AW-XM553 Antenna Connection

The difference

IW611-IW620-D Antenna

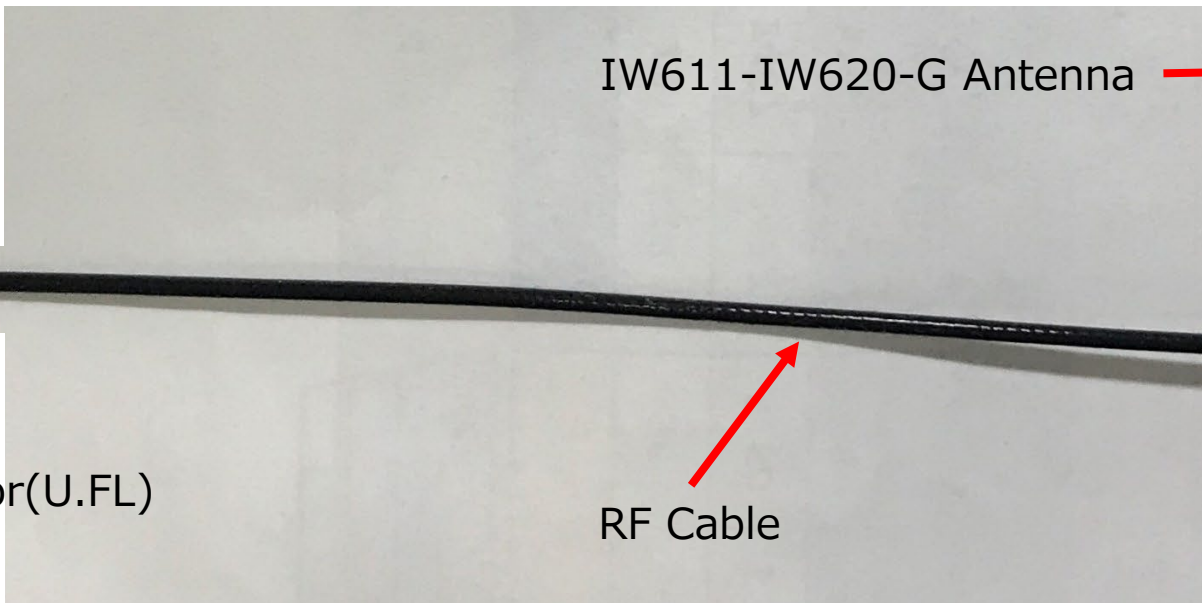
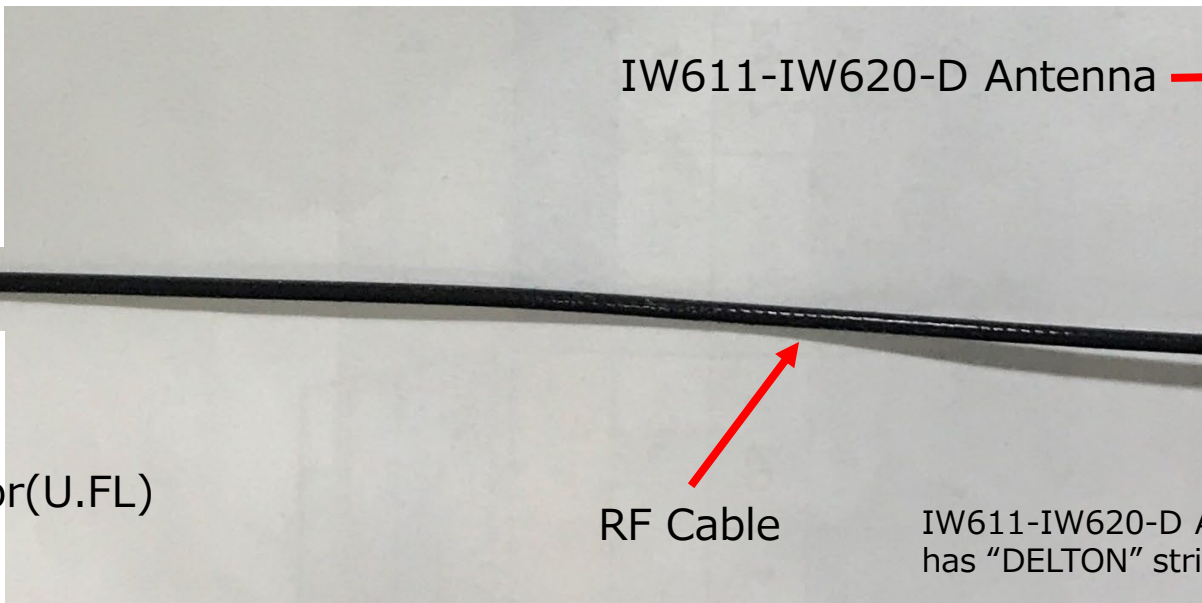
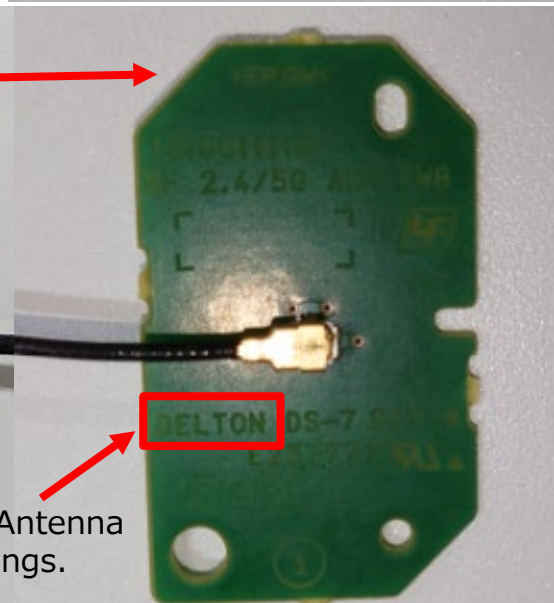
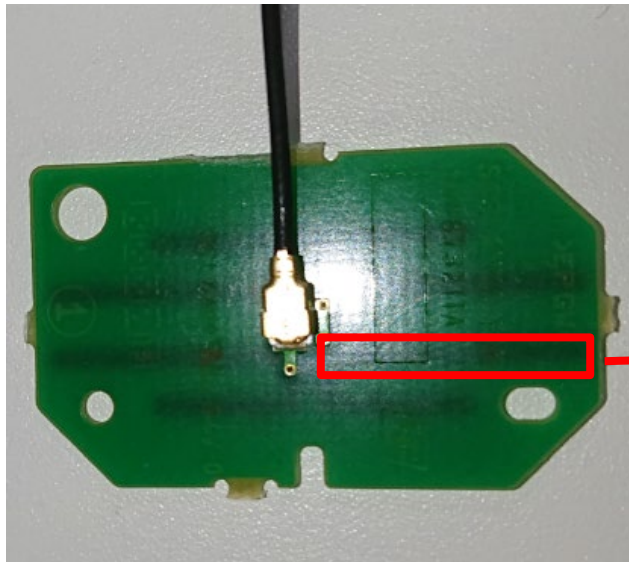
IW611-IW620-D Antenna has "DELTON" strings.

1. Substrate material

2. Antenna pattern

This length is different.

IW611-IW620-G Antenna: 14.25mm

IW611-IW620-D Antenna: 14.00mm
